Details of Change:

For the detailed product list showing the various scenarios, please refer to a separate file called: "Products list-for customer IMO-AB-22-0023-1.xlsx"

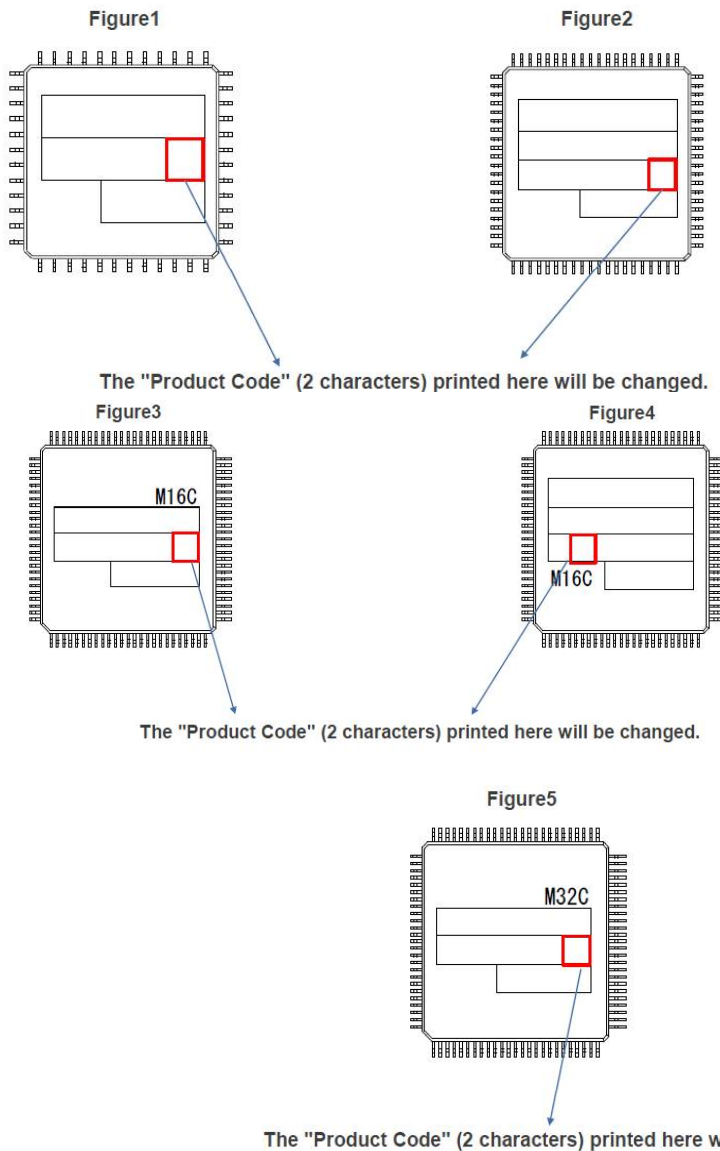
Materials	Mold compound	Wire	Frame	Solder plate
The contents of change	Mold compound A ⇒ A or B Mold compound B ⇒ B	Cu ⇒ Cu Cu or Au ⇒ Cu Au ⇒ Cu	100pin: Reduce two frames. 80pin : Reduce one frame. 48pin : No change	Sn ⇒ Sn SnCu ⇒ Sn
Purposes	- Basically, mold compound is unified to B. - For some products, stable production is realized by switching between material A and material B.	Unified to Cu wire.	- Improve procurement by reducing the types of frame.	Unified to Sn.

Mold	Wire	Frame	Solder plate	Mark	Factory
A ⇒ A or B B ⇒ B	Cu ⇒ Cu Cu or Au ⇒ Cu Au ⇒ Cu	100pin: Reduce two frames. 80pin : Reduce one frame. 48pin : No change	Sn ⇒ Sn SnCu ⇒ Sn	There are changed products.	RSB ⇒ RSB RSB, ATJ ⇒ RSB
Please contact us for explanatory materials regarding the combination of changes in the red letters.				- Before and after changing the mark character: refer to "IMO-AB-22-0023-1"	- Products: refer to "IMO-AB-22-0023-1"
